MITSUBISHI MU-2 AIRPLANES; Availability of Special Certification Review

Subject: ACTION: Mitsubishi MU-2 Special Certification Review (SCR) Program

SPECIAL CERTIFICATION REVIEW OF MITSUBISHI MU-2

FINAL REPORT

The following schematic diagram describes this specific installation:

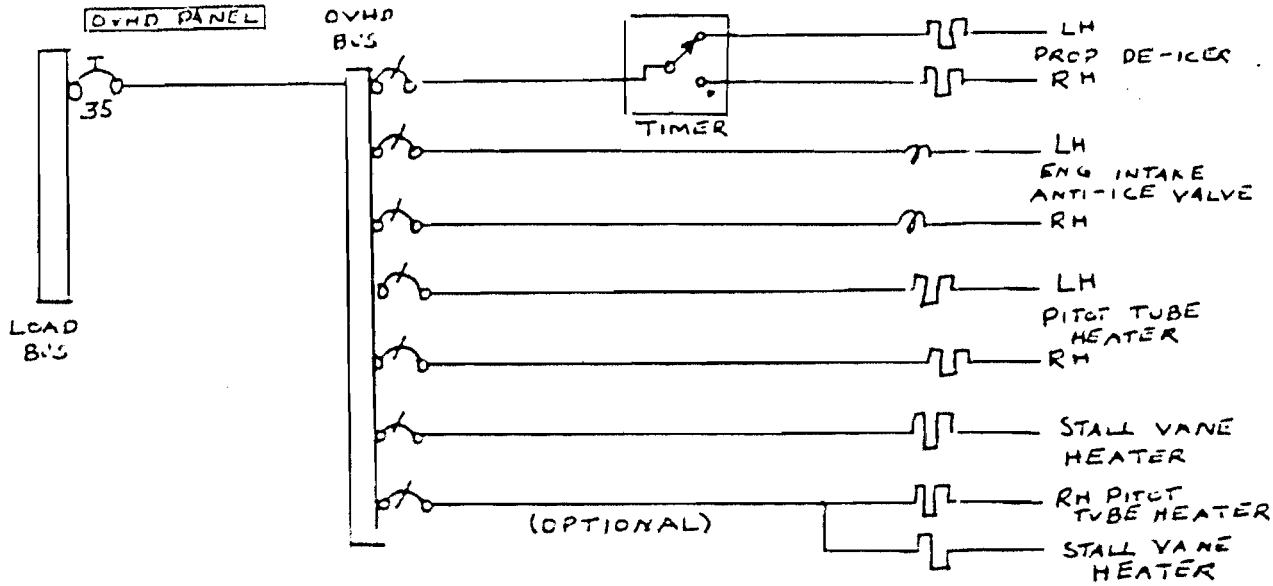
On all Model MU-2 airplanes, review, by a failure mode and effect analysis, the adequacy of the single circuit to provide reliable power to the systems powered by the overhead deice panel.

A. The overhead deice system, which is powered by a single circuit breaker, is installed on FAR 21.29 MU-2 airplanes S/N 239 through 347 (excluding S/N 313, 321) for the short models and S/N 501 through 696 (excluding S/N 652, 661) for the long models. On these airplanes, this bus, designated OVHD, powers the following loads:

1. LH/RH propeller deicer heaters.
2. LH/RH engine intake anti-ice valves.
3. LH/RH pitot tube heaters.
4. Stall warning vane heater.

B. A failure mode and effects analysis of the circuit follows:

1. OVHD circuit breaker fails open:

b. If the above systems are not being operated, there will be no effect on the operation of the airplane (e.g., not in icing conditions) but the failure will not be annunciated to the pilot.

A photo and sketch of the calibration ramp is shown below:

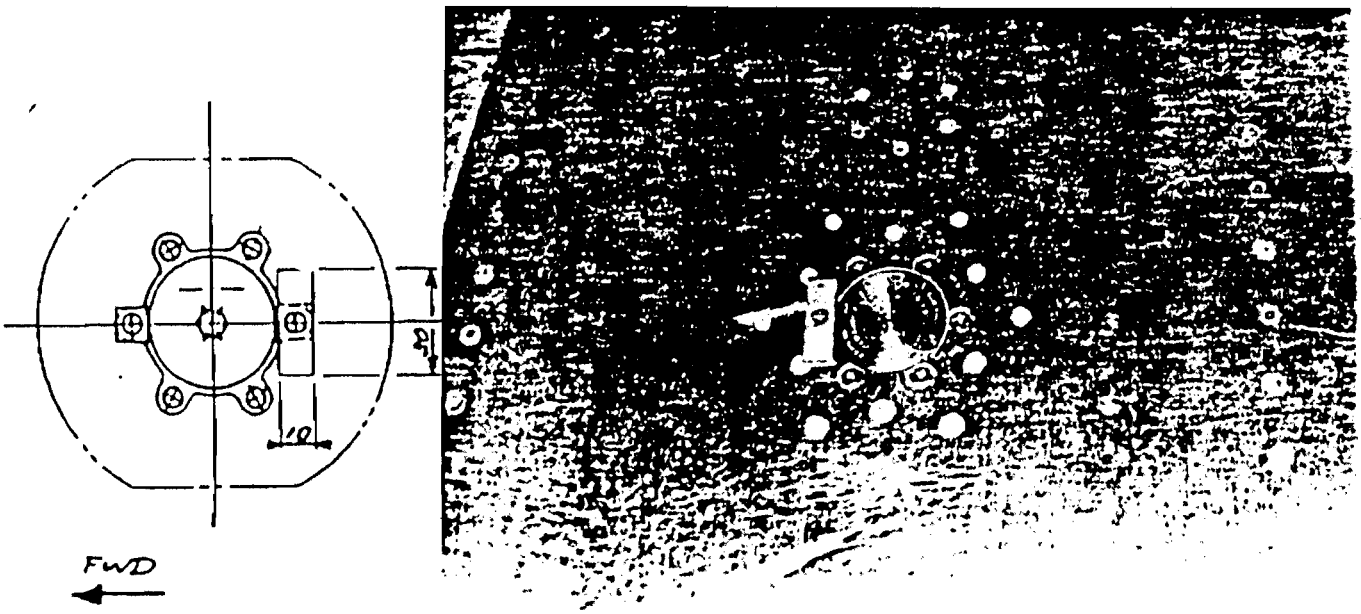
On all MU-2 airplanes, review any static pressure adjustment made by the method of attaching a metal spacer to the external surface of the airplane aft of the static port. Determine the adequacy of the static port ice protection system to prevent ice buildup as a result of the spacer.

The MU-2 airplanes utilizing the static port calibration ramp (metal spacer) are all short bodied MU-2 A10SW airplanes. MU-2B-25, S/N 313; MU-2B-26, S/N 349; MU-2B-26A, S/N 321, 348, 350 through 394; and MU-2B-40 395 and up.

Use of a static port calibration ramp to calibrate an aircraft static system is not a new or novel idea. NA265-40, BS-125, and some Lear models, to name a few, utilize static port calibration ramps.

We know of no service difficulty reports due to static port calibration ramp installations or of ice accretions on the ramps. The MU-2 mounted ramp is attached with a screw that is connected directly to the heated port, and it is reasonable to believe that there is a level of thermal conductivity between the static port and the calibration ramp. In addition, the calibration ramp is within the boundary layer of the fuselage and, therefore, should be considered ice accretion free.

Static port left side of aircraft
Note: Plumbing run uphill (MU-2-40) (right side same)

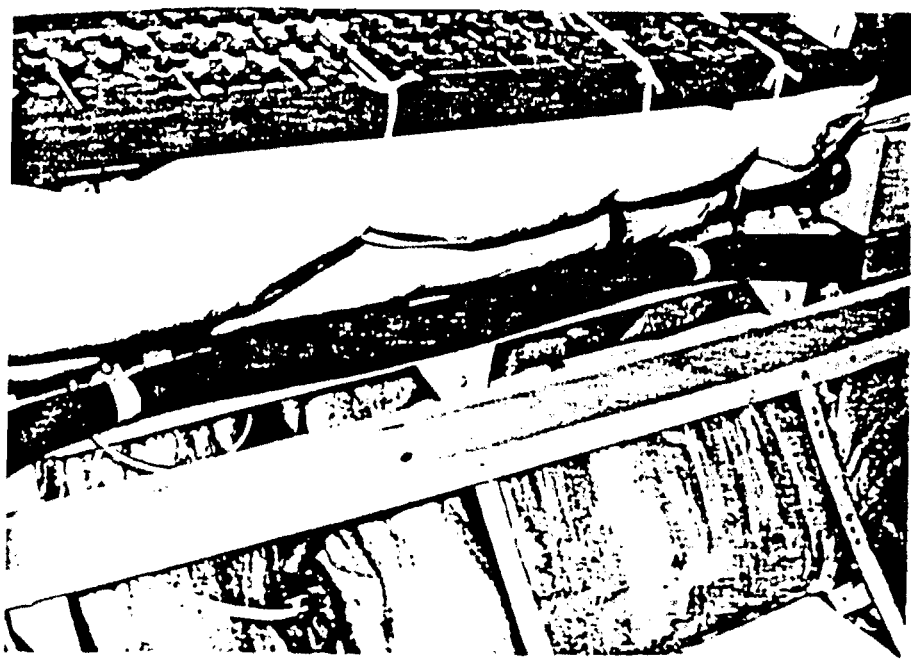
On all MU-2 airplanes, review the pitot pressure and static pressure system designs to determine if the designs are vulnerable to moisture accumulation and entrapment which may cause system pressure blockage particularly when the moisture freezes.

Static system:

As can be seen on the photos below, all static system plumbing is located on the conditioned air (heated) side of the fuselage. In addition the plumbing for the static system is running "uphill" from the static port to the instrument panel. At the instrument panel, the static lines are routed, as necessary, with a moisture trap at the lowest point. The trap has a capacity of approximately 6.6 cc.

During MEOT Flight SCR-20-30 on February 9, 1984, the aircraft was flown through moisture and through a moderate to heavy 45-minute icing encounter. Four-five inches of ice were accreted on unprotected surfaces. No anomalies in the pitot/static system were reported. After the flight, the system drains were opened and no moisture was detected. In addition, Mitsubishi conducted a random field study to determine if moisture was trapped in the pitot/static system. Out of 37 airplanes checked, only three were found to have trapped moisture in the sumps with six drops being the maximum found.

Mitsubishi has voluntarily committed themselves to revising the Aircraft Maintenance Manual to amplify the importance of draining the pitot/static system after flying through rain and in addition to keep covers on the pitot/static ports when washing the airplane. They are also planning to add a note in the flight manual instructing the pilot to inform maintenance personnel when the aircraft has been flown through heavy rain.

No further action is planned.

Pitot/Static details of sumps and drains MU-2-40

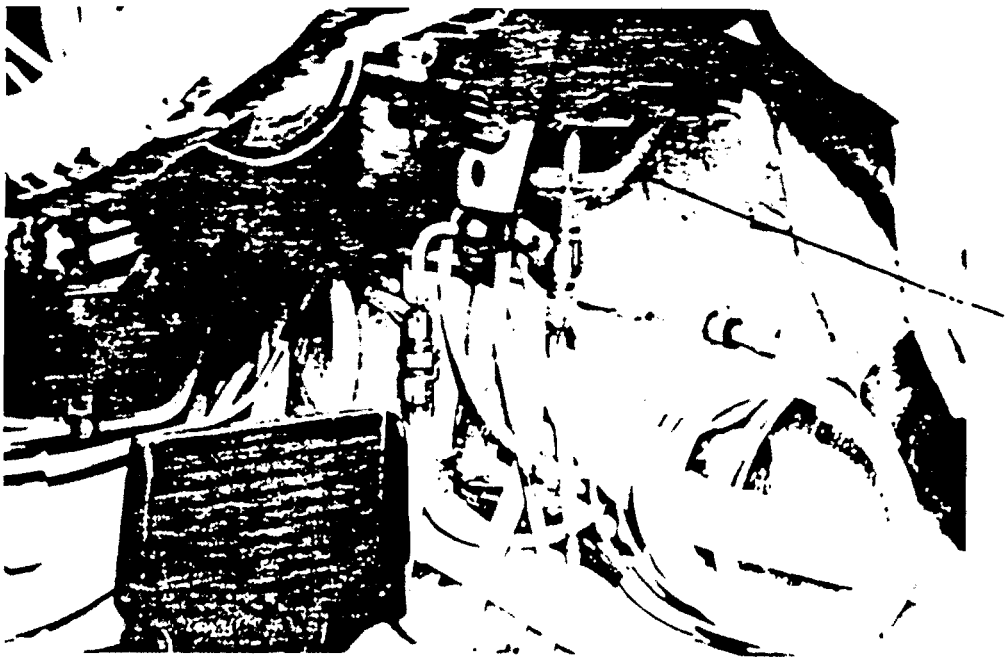
All pitot system plumbing is also located in the conditioned air (heated) side of the fuselage. As can be seen on the photos below, the pitot pressure line enters the fuselage and immediately goes "downhill" into a "T" fitting and into a moisture trap with a capacity of 6.6 cc for the RH trap and 6.3 cc for the LH trap.

Right pitot line showing line tee'd directly into sump and drain, MU-2-40 (left side same)

Field Approved Alternate Static Source Selector Location

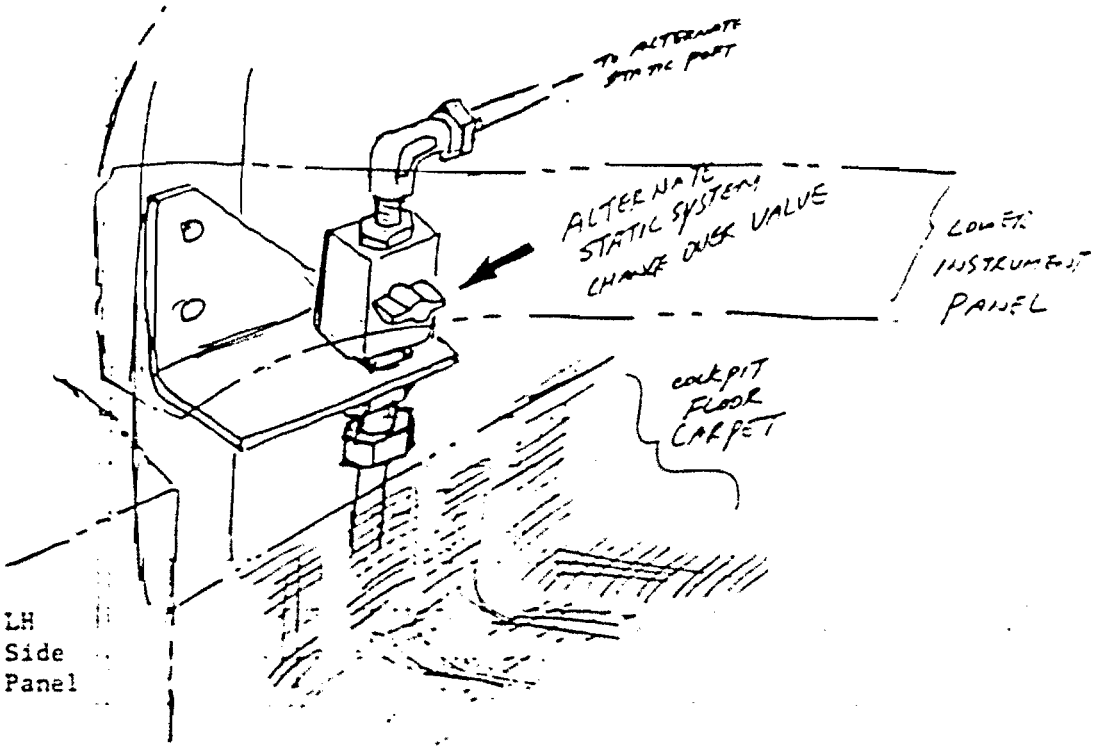
On all Model MU-2 airplanes, review the location and identification of the alternate static source controls. Determine if the alternate static source control is sufficiently accessible and properly identified to the pilot. Review must consider the loss of the primary static system or function during critical portions of a flight and the selection of the alternate static is required.

There are basically two types of alternate static source designs that were incorporated on MU-2 airplanes.

Both alternate static system designs have been reviewed and are found to be airworthy. However, during the SCR team review at least five airplanes with the field approved alternate static system with field approved interiors were found, after aircraft delivery, to have the alternate source selector covered with wire bundles or interior materials.

Conclusion: The field approved and type design alternate static systems have been reviewed and determined to meet airworthy standards. However, information surfaced during the SCR investigation that points toward improper installations of interior or at least five airplanes subsequent to aircraft leaving the Mitsubishi factory.

Since this is a maintenance induced problem, on an FAR 21.29 airplane, we recommend that the Small Airplane Certification Directorate work with the appropriate Flight Standards Office to have the condition corrected.

ELECTRICAL SYSTEM SCHEMATIC

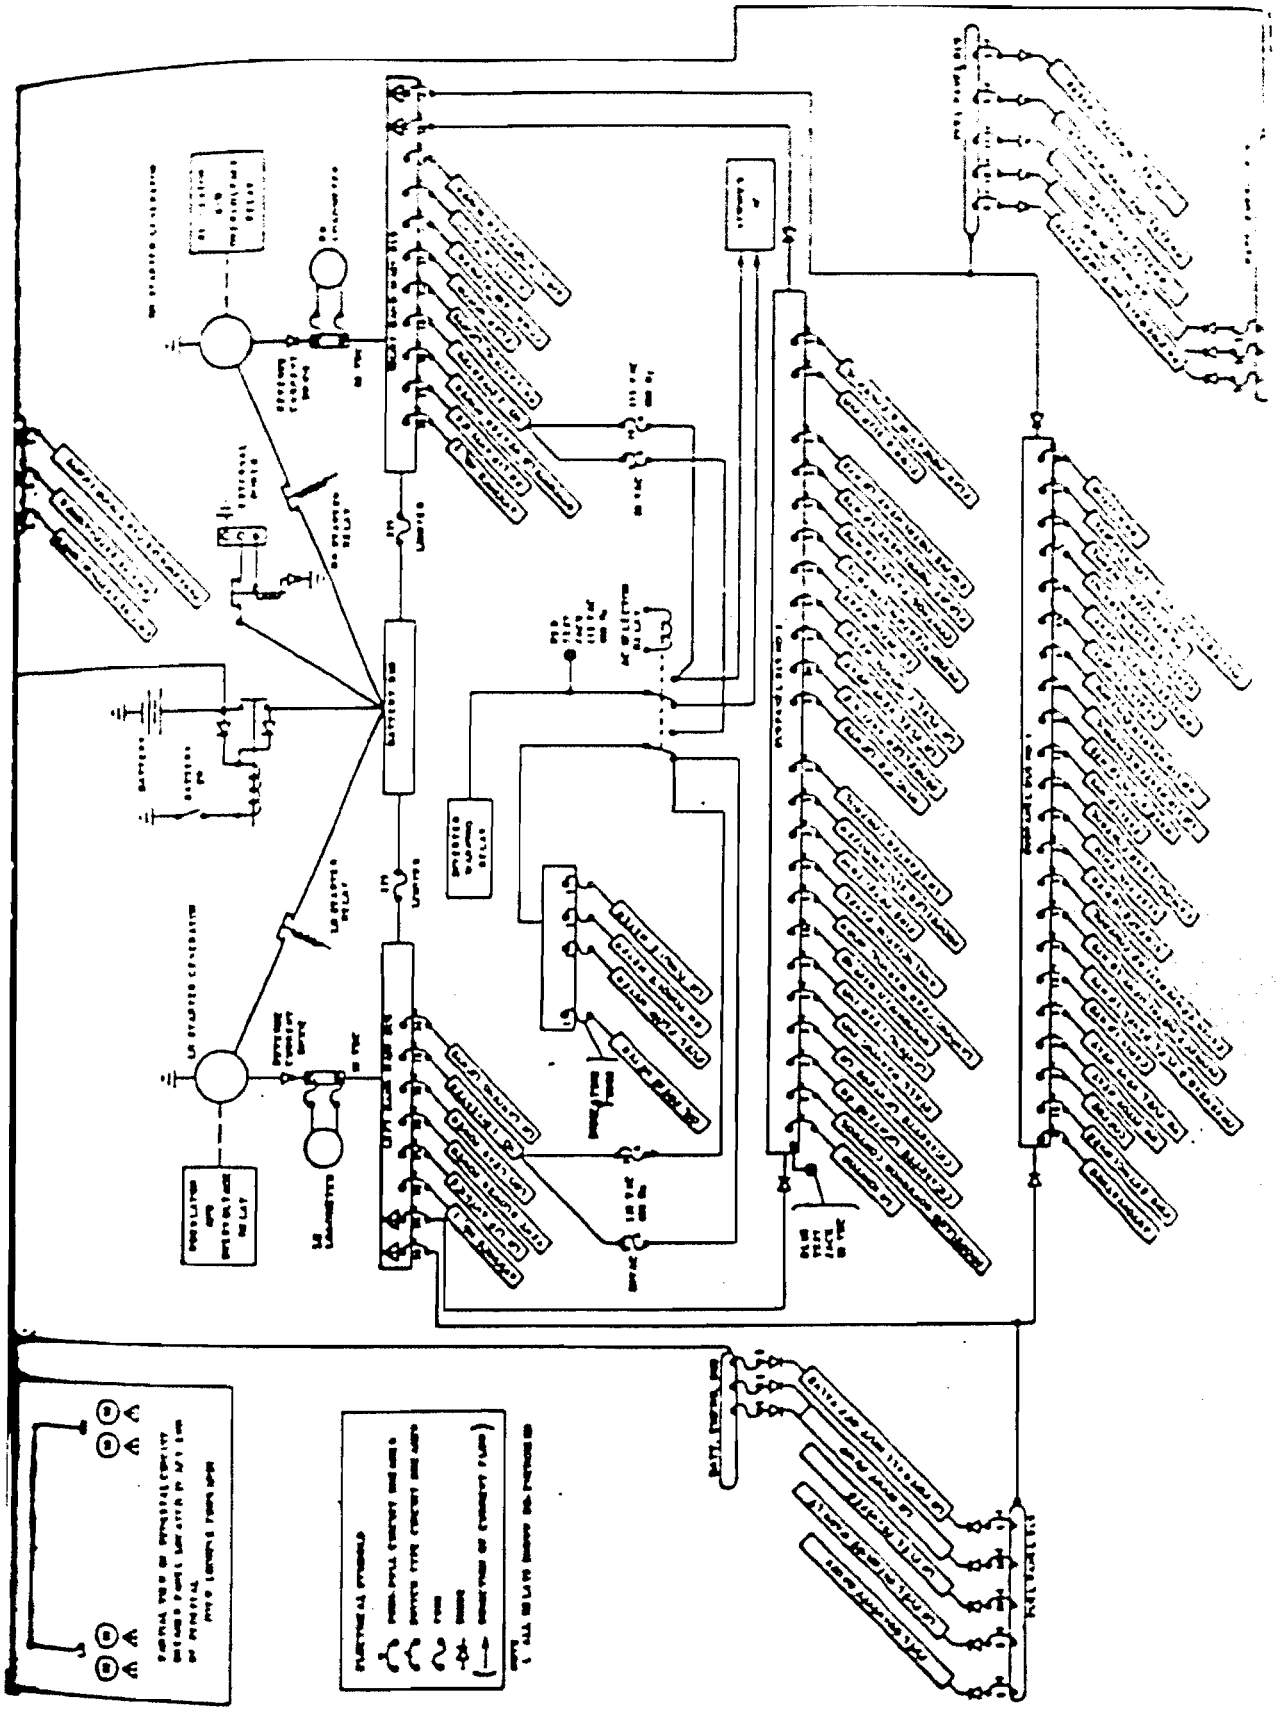
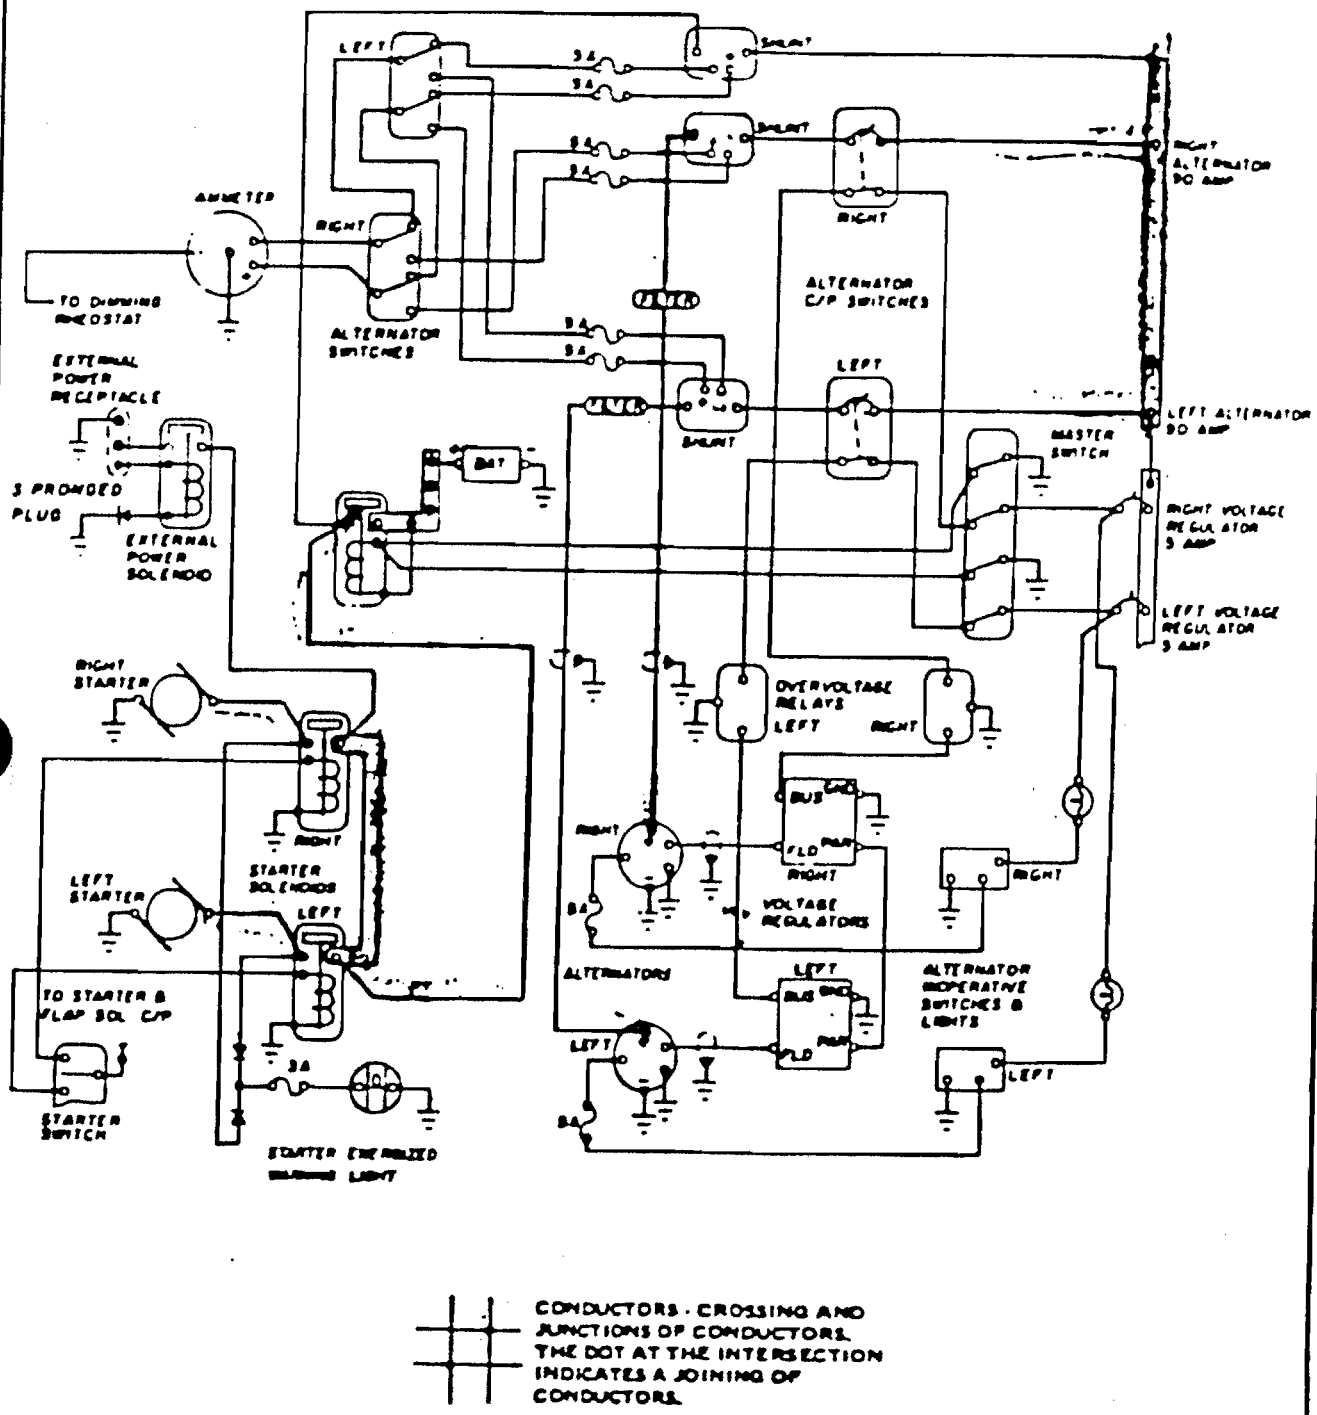
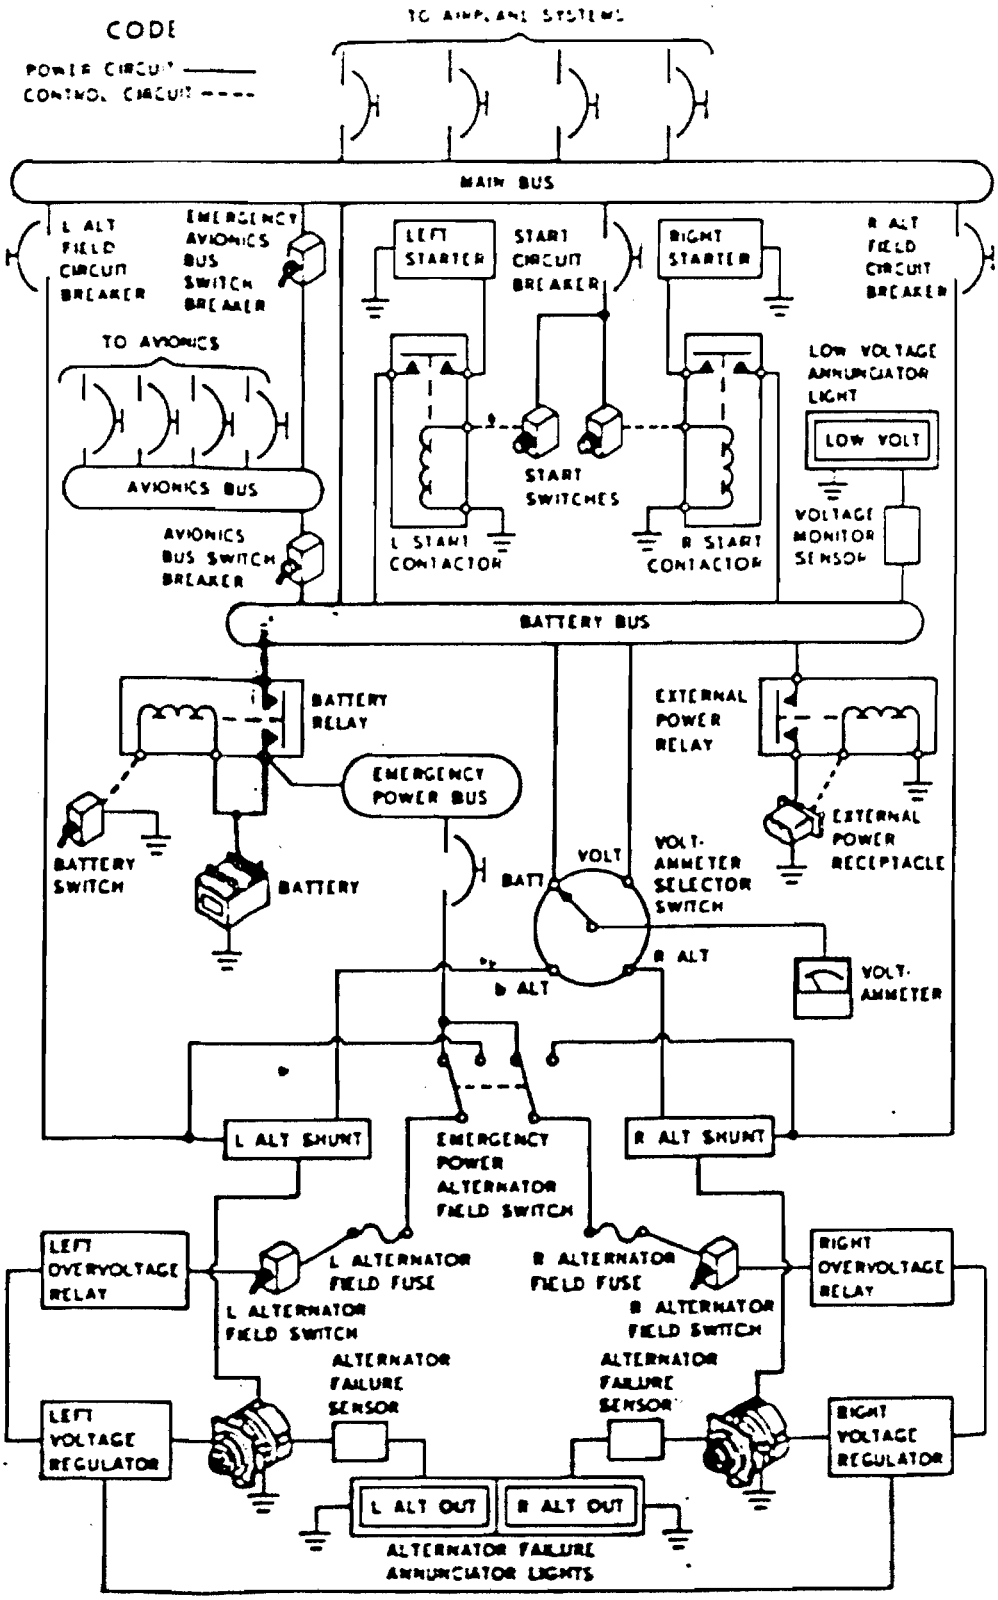
1. All MU-2 FAR 21.21 airplanes have a split bus and feeder fault protection. Of the A2PC airplanes, the MU2B-30, S/N 502 through 547, and the MU2B-35, S/N 586 and up, have a split bus and feeder current limiters and all the MU2B-36 airplanes have a split bus and feeder fault protection. The remainder of the A2PC airplanes have a single bus with no feeder fault protection. At the time these earlier airplanes were certificated, the single bus with no feeder fault protection concept, with the proper attention given to routing of cables, isolation from flammable fluid, and selection of quality insulation materials was a design accepted as airworthy. The Cessna 414 and Piper PA-31 are typical examples of this vintage airplane which have a single bus and no feeder fault protection. The Beech King Air C90 has a split bus but also does not have feeder fault protection. Copies of the schematics of these airplanes are attached.

To this date, the service history of the electrical systems on these airplanes has shown them to be safe and reliable. Evidently, the finding was made when they were FAR 21.29 type certificated that the method of insulation and isolation design which was used when installing these systems enabled them to come under the CAR 3.690 category where protective devices need not be installed "where no hazard is presented by their omission."

We see no reason, at this time, to challange the validity of that finding.
